**Re: Defect Information Report – Supplemental Report No. 2
10V-468 & 10V-472, 10C-6, MBE900 EPA07 Reprogramming**

**Subject: Safety Recall 10C6
MBE900 EPA07 MCM Reprogramming In School Bus and
Emergency Vehicle Applications**

Subject: **Safety Recall 10C6**
MBE900 EPA07 MCM Reprogramming In School Bus and
Emergency Vehicle Applications

Figure 1 – Software And Fuel Map Version Number

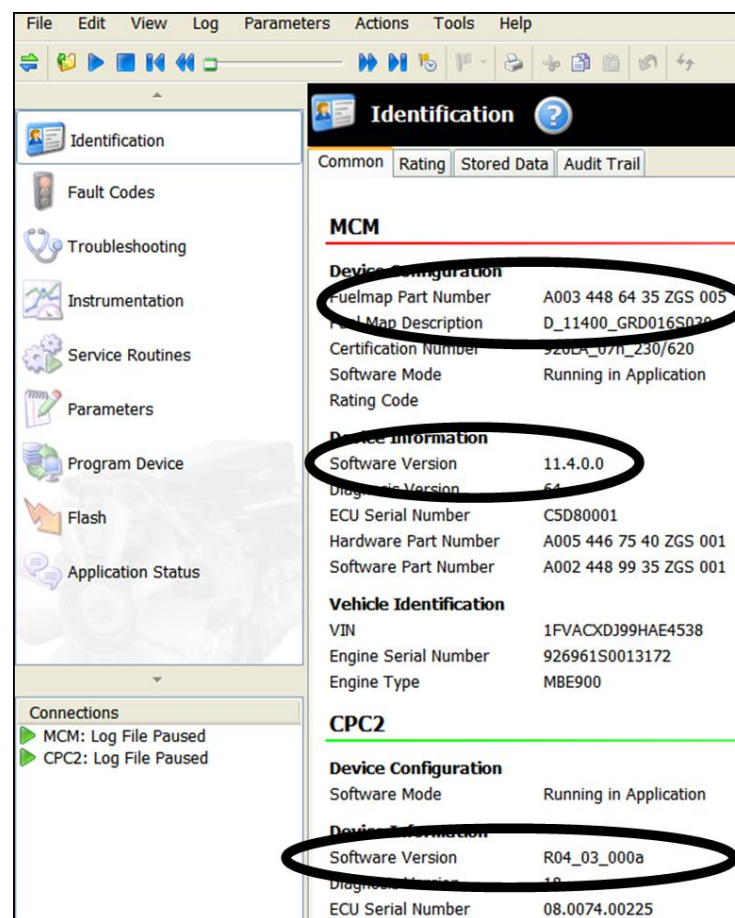
1. Apply the parking brake, chock the wheels, and perform any other applicable safety steps.
2. Using the "Identification" screen in DDRS, check the MCM software level and fuel map version number. See Figure 1. In this example, the MCM software level is 11.4.0.0 and the fuel map version is the last three digits of the fuel map part number after the letters ZGS which is 005.

4. Using the “Identification” screen in DDRS, check the CPC software level. See Figure 1. In this example, the CPC software level is r4.03. If the CPC is not at r4.03 software or higher, program it using the “Update Device Software” option. Select “No Charge”, then “Description”, and enter “10C6” in the “Provide Reference” box.

3. If the MCM is not at software 11.4.0.0 with fuel map version 005 or higher, program it to 11.4.0.0 or higher using the “Update Device Software” option. Select “No Charge”, then “Description”, and enter “10C6” in the “Provide Reference” box.
